Re: Bridgewater Place Tower - On-Site Verification of Wind Microclimate Conditions

RWDI 1900495

BWP – FINAL SUMMARY

03/10/2019 rev04 Final

GROUPED POINTS

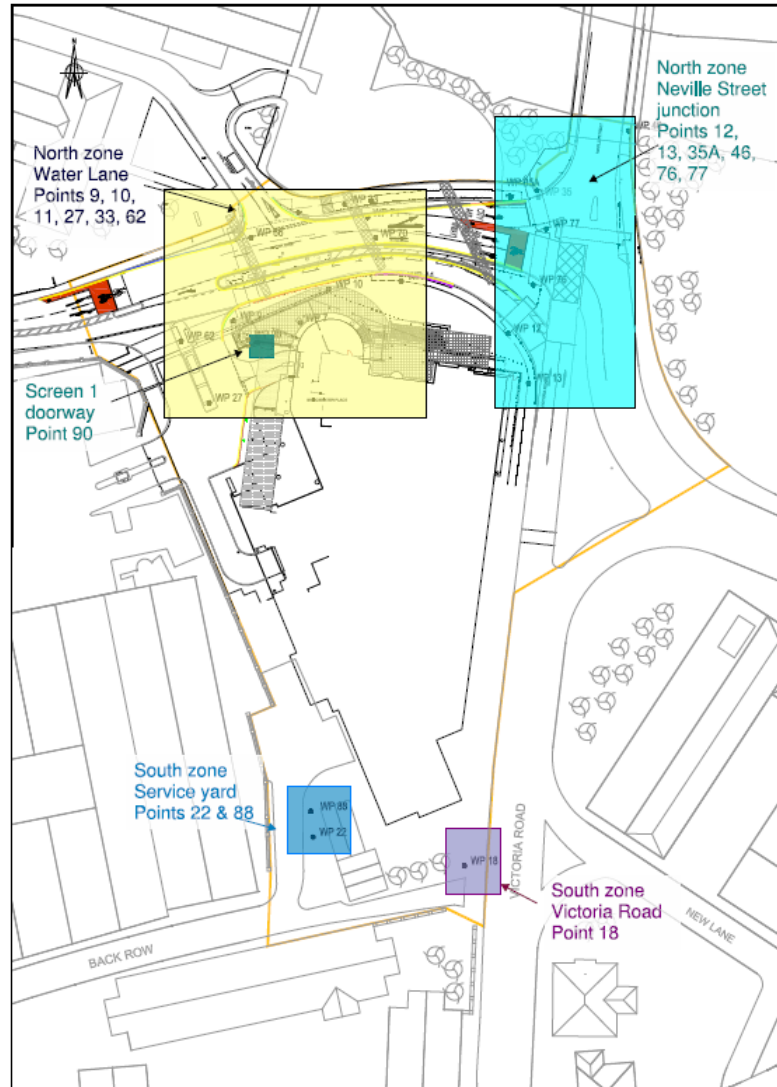
- This shows that at the front of the building there are no Lawson failures at 15 m/s.
- This is a better position than that predicted by both the wind tunnel and the CFD analysis.
- There are 2 points which failed the Lawson safety criteria (at 15 m/s):
 - Wind point 88 – Service Yard;
 - Wind Point 18 – Courtyard at rear of Bridgewater Place.
- In addition, CFD analysis showed a possible marginal failure on Back Row by the Grove Inn. This point was not tested (but is being tested).

TEST POINT FAILURES (AT 15 M/S)

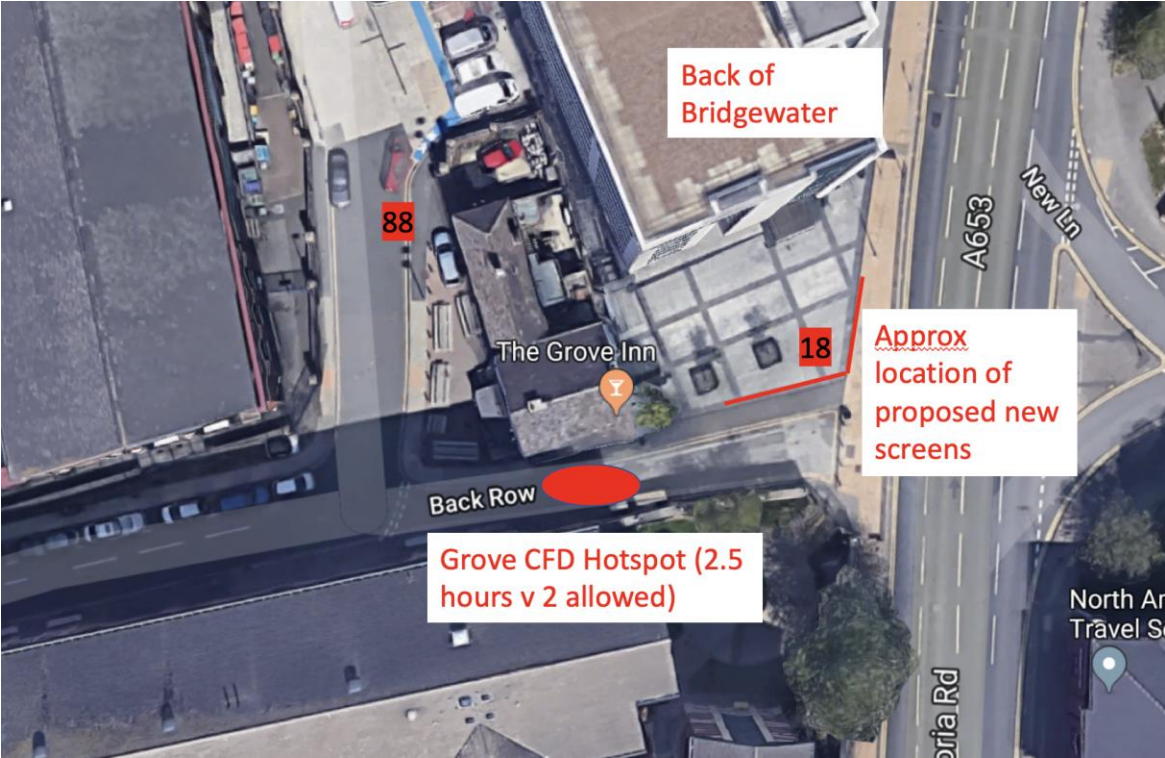
Potential measures to deal with the 2 wind test point failures were discussed, as well as the predicted marginal failure at Back Row based on CFD analysis.

Wind test point 88

- We understand that this is being dealt with by way of a management protocol and so no physical measures are required.

Wind test point 18

- We have used CFD analysis to model the improvement to this area using 50% porous screens, and this shows a good improvement which we would expect (subject to detailed design work) to resolve the failure.
- The next slides show the images of the screens and their locations.
